Subject: Project Manual and Plan Drawings and Soil and Groundwater Sampling Plan and Closure Plan, Intake and Discharge Tunnels, Former Seabreeze Yacht Center, Oakland

**Subject: Soil and Groundwater Sampling Plan and Closure Plan, Intake and Discharge
Tunnels, Former Seabreeze Yacht Center, Oakland, California**

SOIL AND GROUNDWATER SAMPLING PLAN AND
CLOSURE PLAN
INTAKE AND DISCHARGE TUNNELS

FORMER SEABREEZE YACHT CENTER
Oakland, California

PROPOSED GRAB SOIL AND GROUNDWATER SAMPLING LOCATION

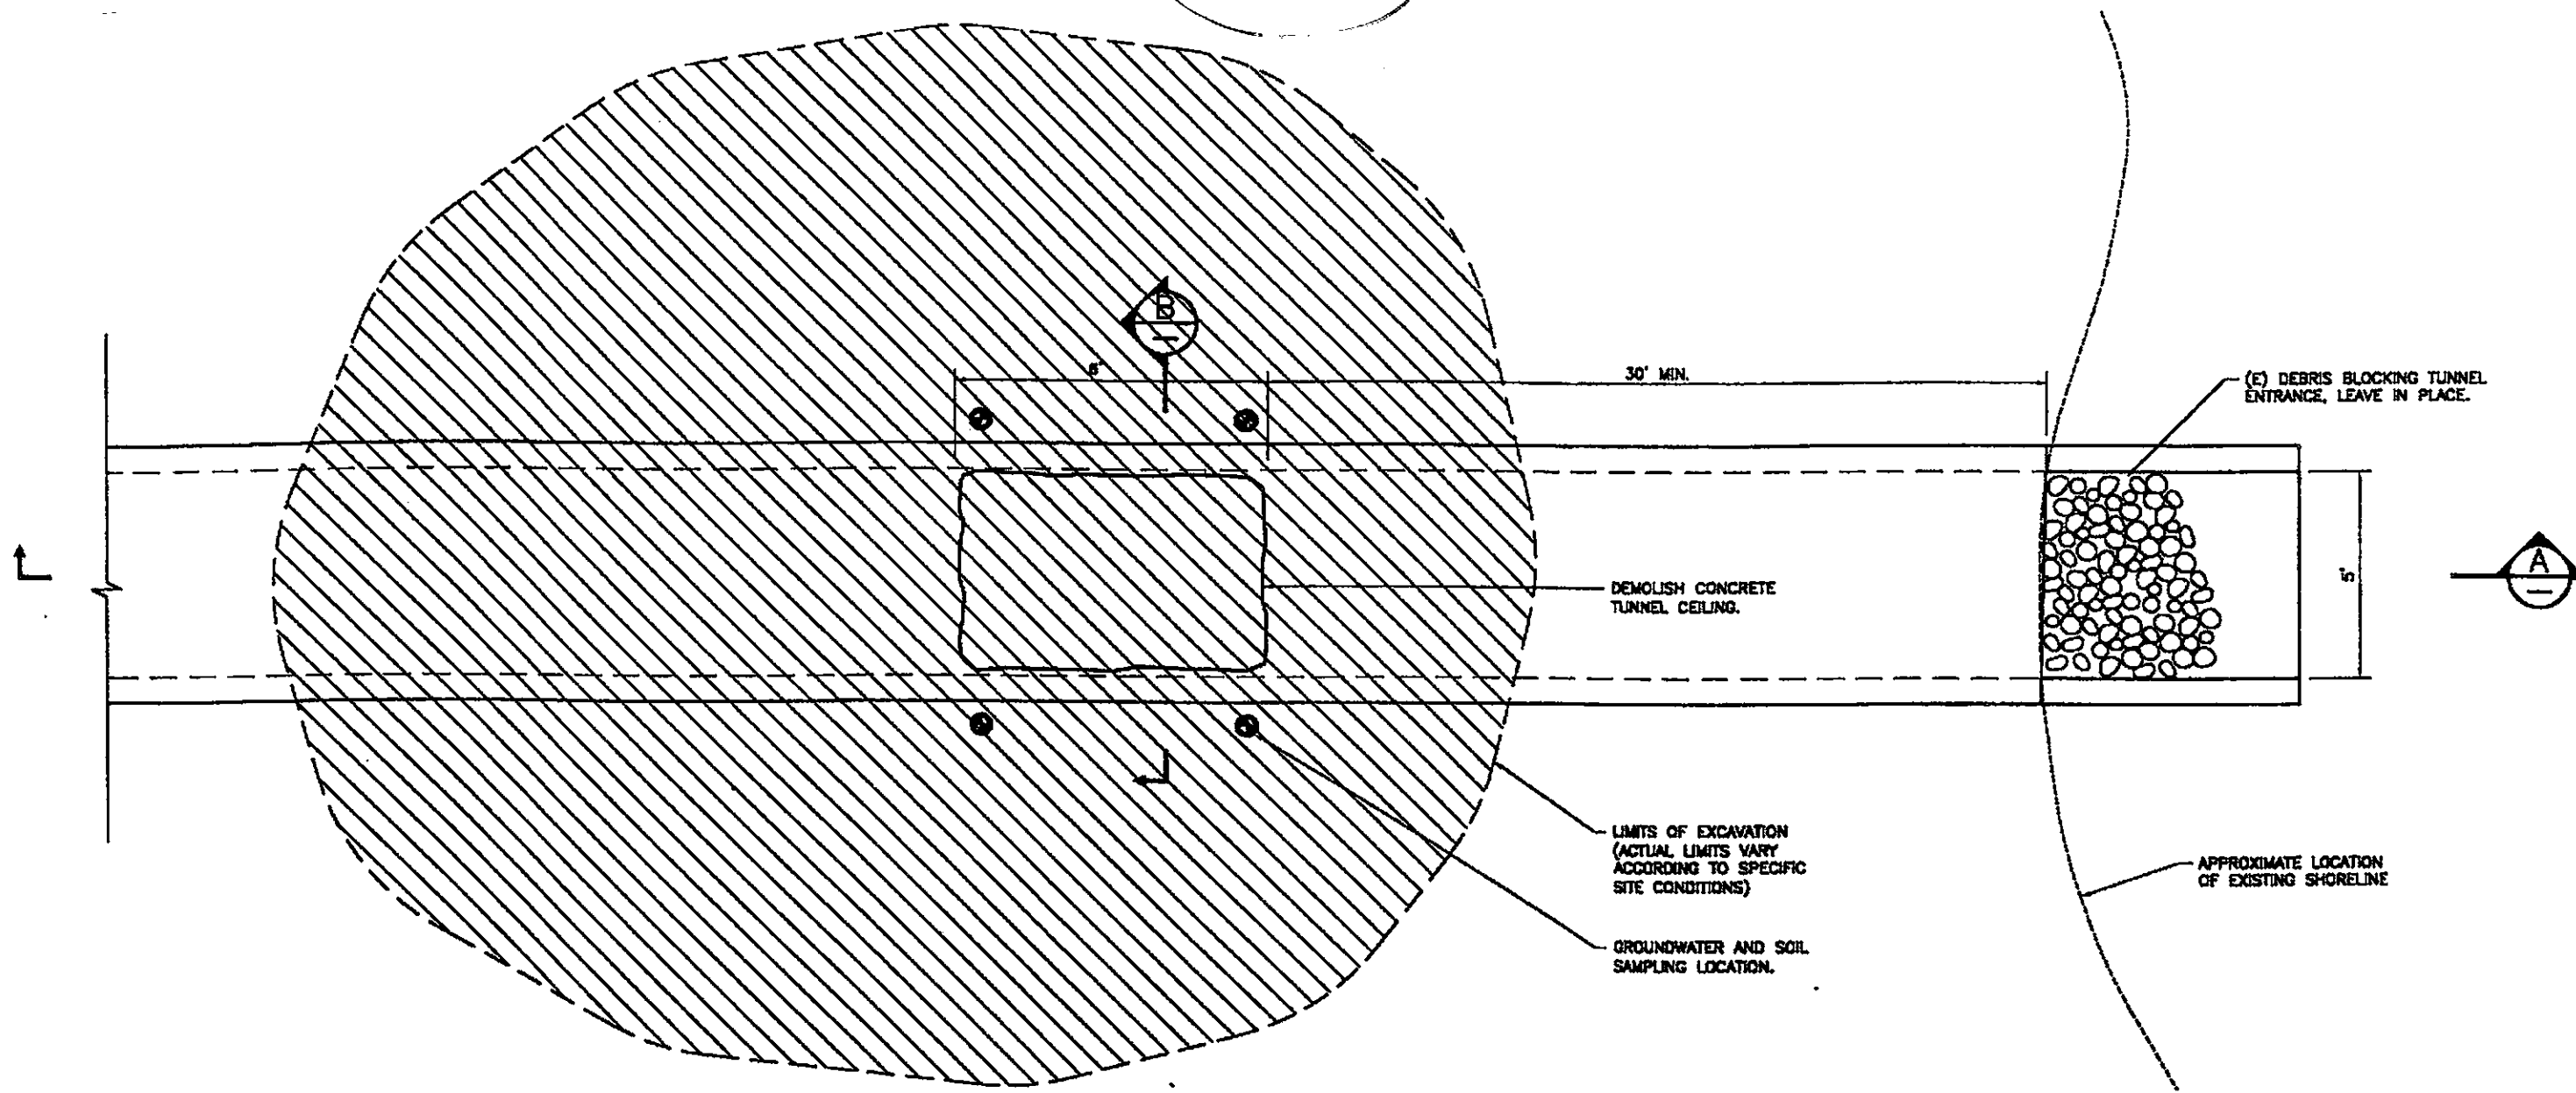
Is compositing reasonable?

Any criteria for selecting the 2 locations?

why not the deepest soil core? / any sp s/b disposed
